Subject: **Preliminary Comments Regarding Salinas Valley Basin Groundwater Sustainability Agency Draft Groundwater Sustainability Plan Chapters 1 through 3 (EKI B60094.03)**

Subject: **Preliminary Comments Regarding Salinas Valley Basin Groundwater Sustainability Agency Draft Groundwater Sustainability Plan Chapter 4 (EKI B60094.03)**

Subject: **Preliminary Comments Regarding Salinas Valley Basin Groundwater Sustainability Agency Draft Groundwater Sustainability Plan Chapter 5 (EKI B60094.03)**

Appendix B
Focused Technical Review of Public Draft GSP

**Figure 3A - Estimated Water Level Decline at Minimum Thresholds in the
180-Foot Aquifer
Salinas Valley Basin GSA**

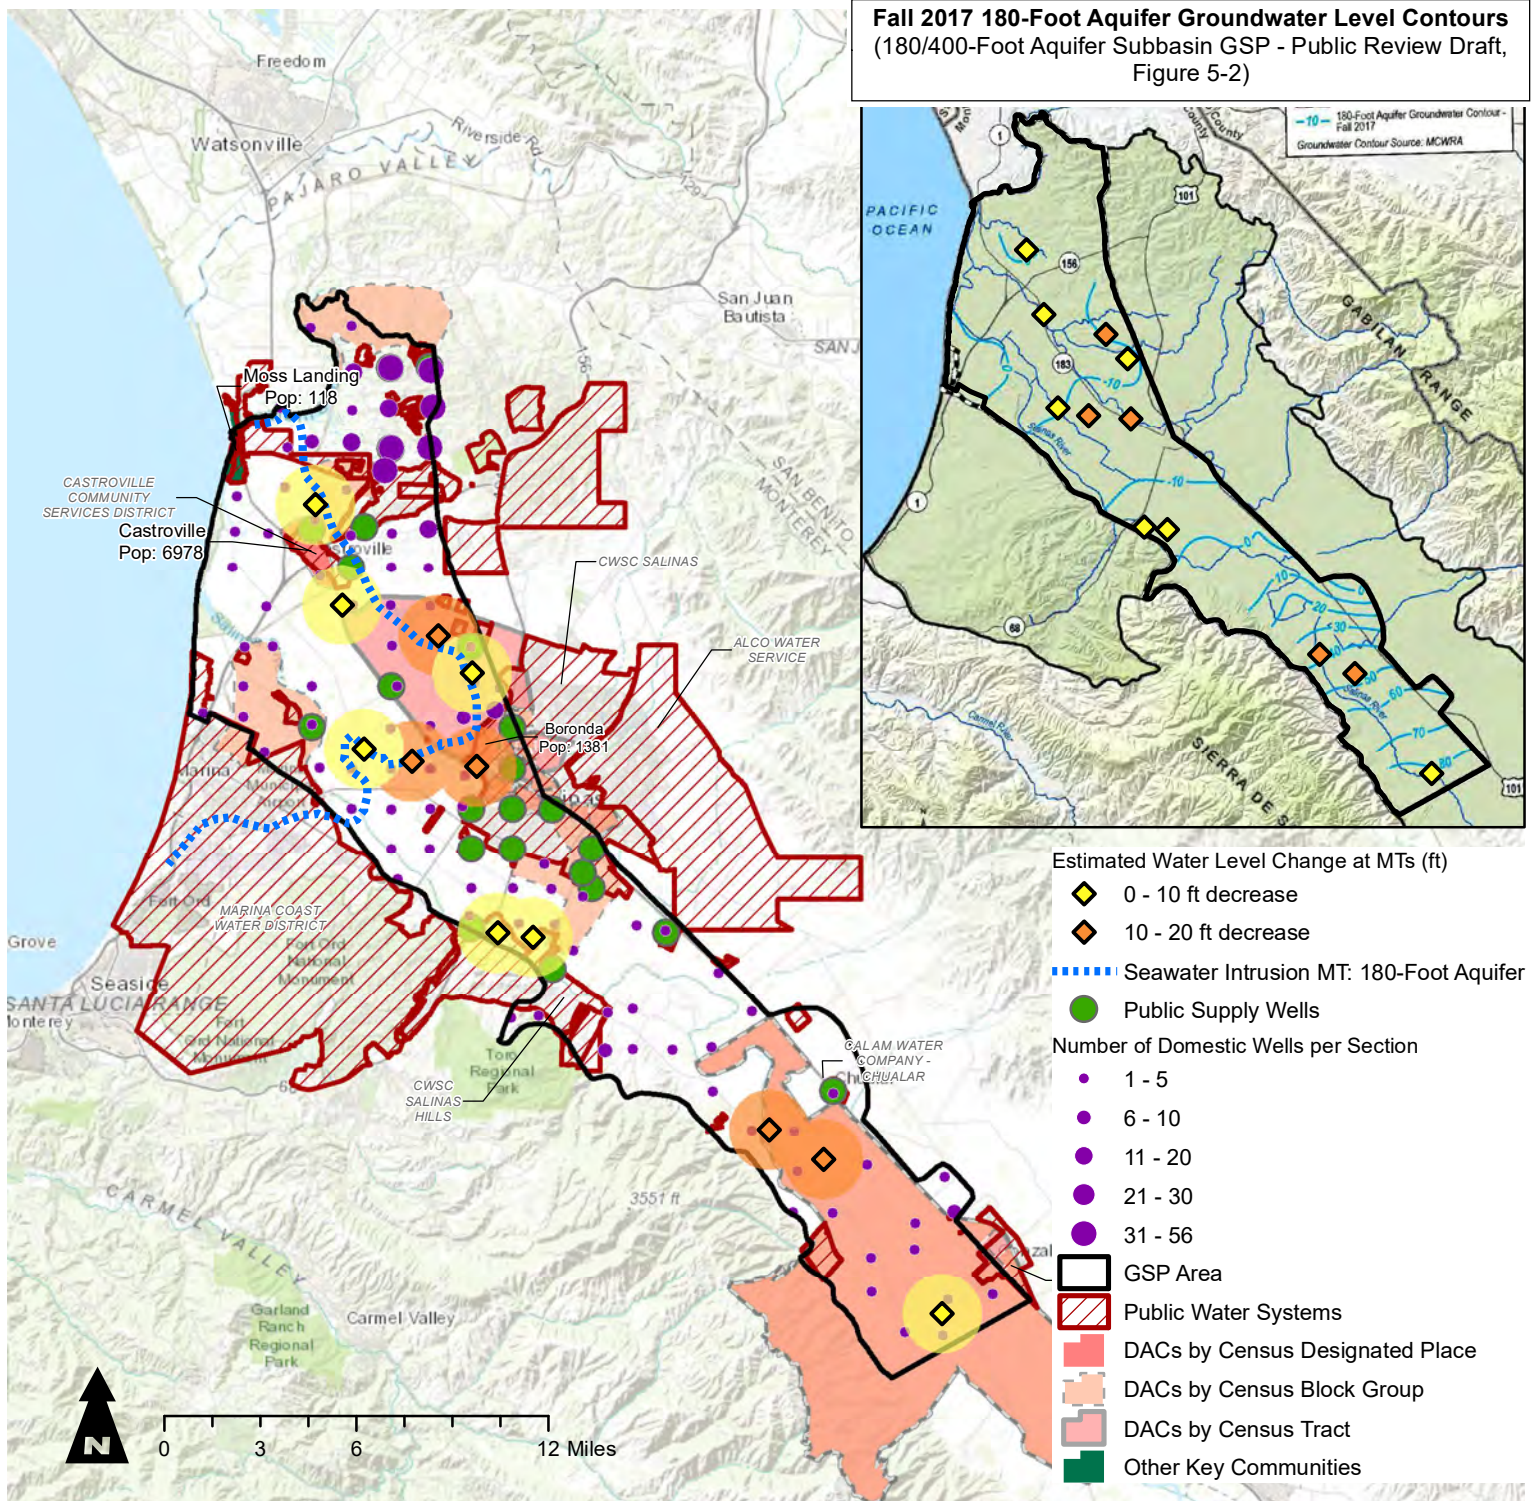
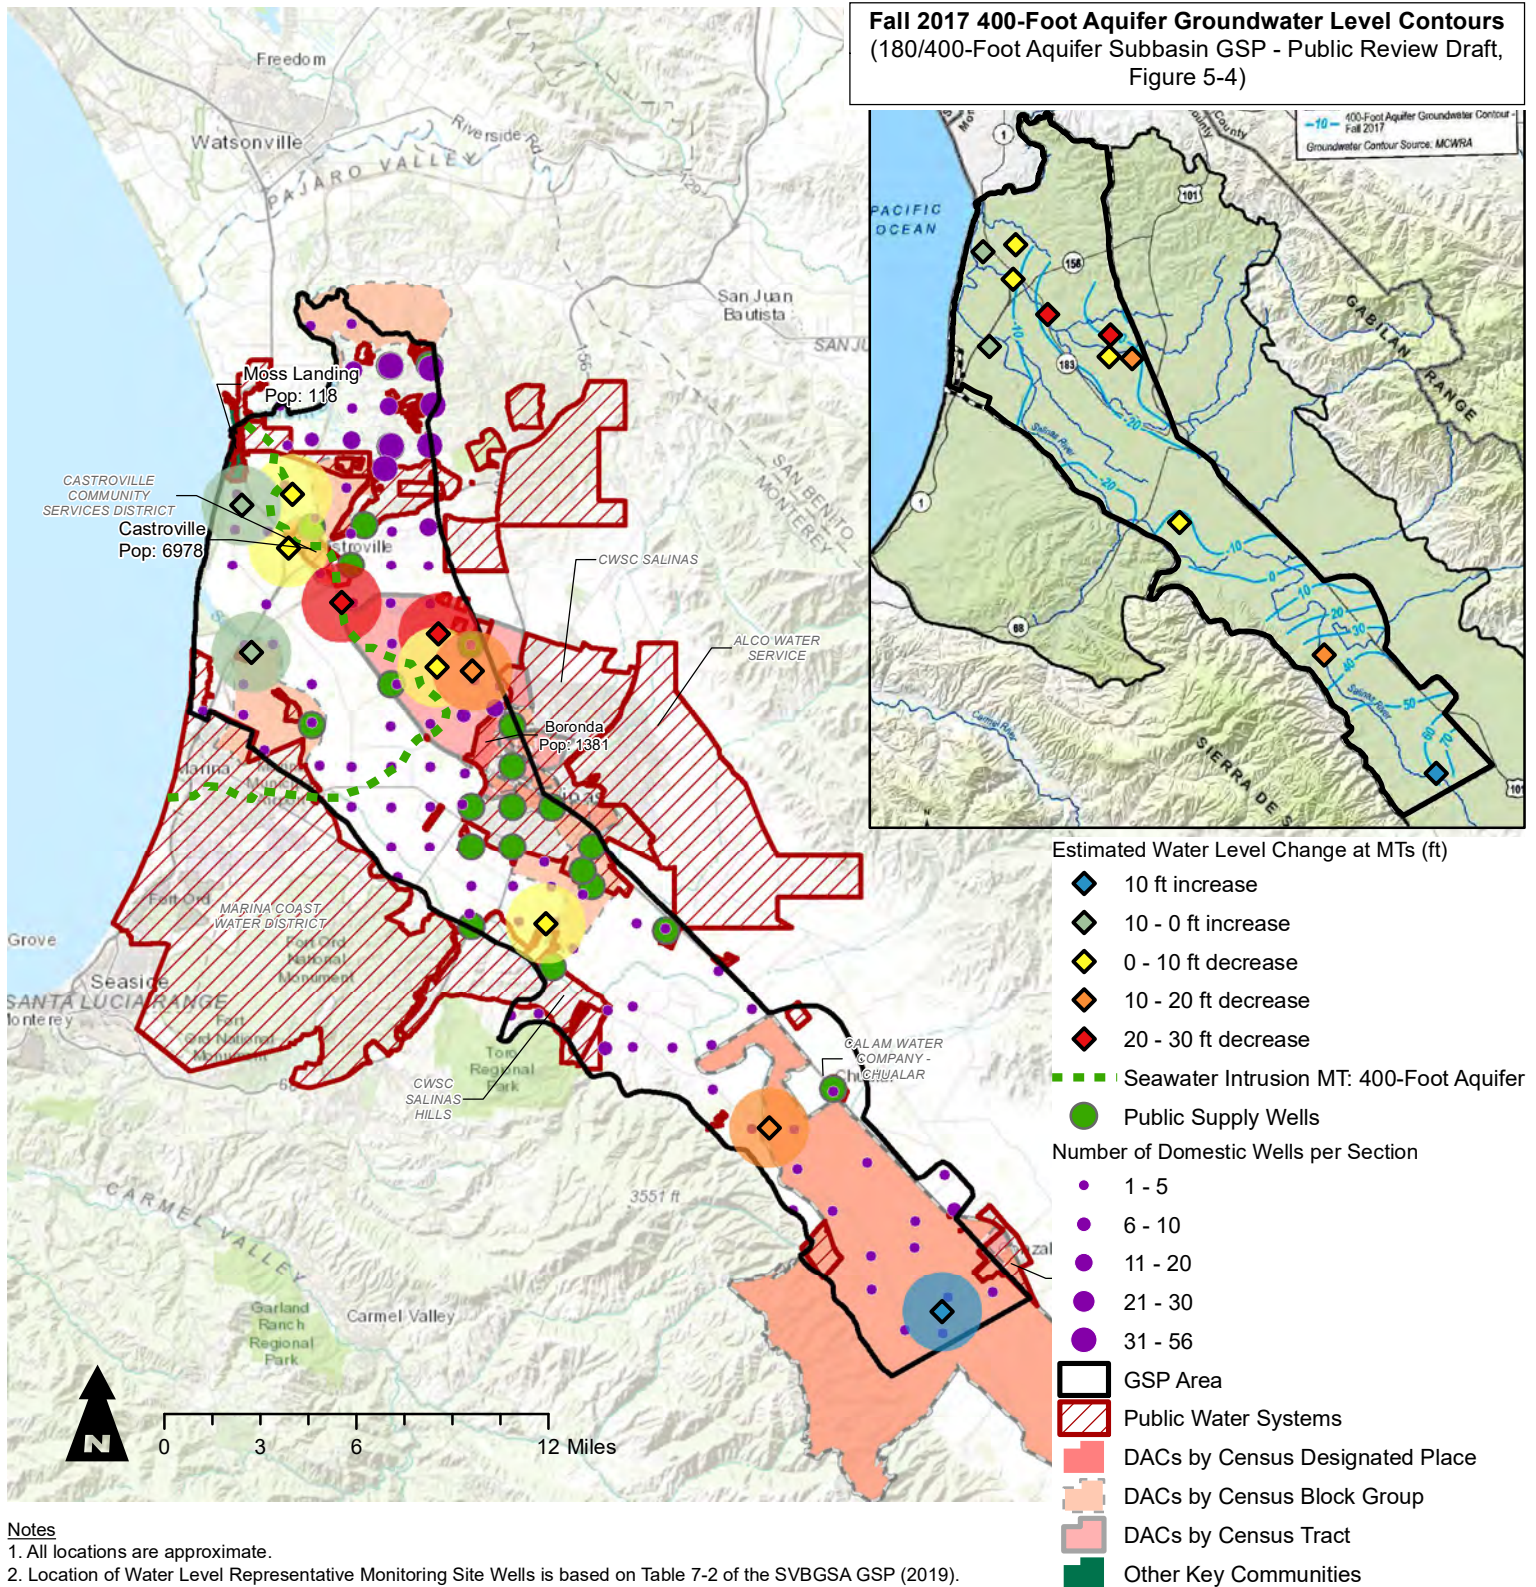
- **Figures 3A and 3B** show the estimated water decline from current conditions that would occur at each RMW if water levels reach the MTs for the 180-Foot and 400-Foot Aquifers, respectively. As shown in Figure 3B, the MTs for two RMWs (14S/02E-03F03 and 14S/02E-12B03) located along the 2017 seawater intrusion line/seawater intrusion MT are more than 20 feet below current groundwater conditions. **The GSP should explain how continued water level declines in areas already or imminently impacted by seawater intrusion will result in sustainable conditions for beneficial users.**
